ADVISORY NEIGHBORHOOD COMMISSION 6E
PO Box 93020 Brentwood Station, Washington, DC 20090

RE: Response to DDOT NOI to Install a Median on New York Avenue NW between North Capitol Street and First Street NW (NOI 21-30-PSD)

Figure 1: NOI Design for the Intersection of First Street and New York Avenue NW

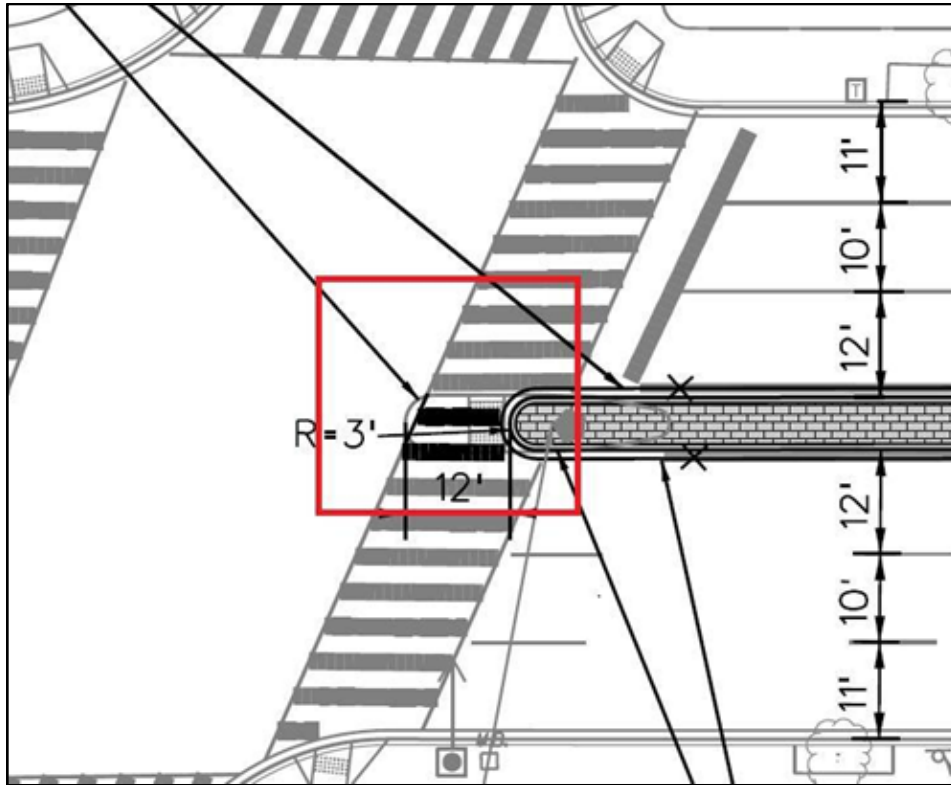
The NOI design ends the median at the east leg of the intersection of New York Avenue and First Street NW, 12 feet before the eastern edge of the pedestrian crosswalk (Figure 1). The current design of the intersection of First Street and New York Avenue NW features a median that extends on either side of the east leg crosswalk to provide a pedestrian refuge island in the center of the busy intersection (Figure 2). In addition to creating a safe area for pedestrians, the existing median design also prevents drivers turning left from First Street southbound New York Avenue eastbound from cutting the corner and forces drivers to take a tighter and more left turn. Drivers frequently collide with the median at this intersection when turning left from First Street southbound onto New York Avenue eastbound.⁵ These collisions are due in part to a lack of visibility for the median. Nearby residents have attempted to improve visibility by placing orange traffic cones on the median, as seen in Figure 2. Collisions with the median are also the result of drivers speeding and driving dangerously through this intersection during off-peak hours. Residents of ANC 6E have requested that DDOT conduct a traffic safety assessment (TSA) to address the fundamentally dangerous traffic conditions at this intersection (Ref: 21-00155439).

- The NOI plans should be modified to extend the median through the crosswalk on the east leg of the intersection of First Street and New York Avenue NW to create a pedestrian refuge island and prevent turning drivers from cutting the corner through the crosswalk.
- The NOI plans should be modified to extend the median through the crosswalk on the west leg of the intersection of New York Avenue NW and North Capitol Street to create a pedestrian refuge island and discourage u-turns.
- The end of the median on the east leg of the intersection of First Street and New York Avenue NW should be clearly demarcated to increase visibility for drivers making a left turn from First Street SB to New York Ave EB.
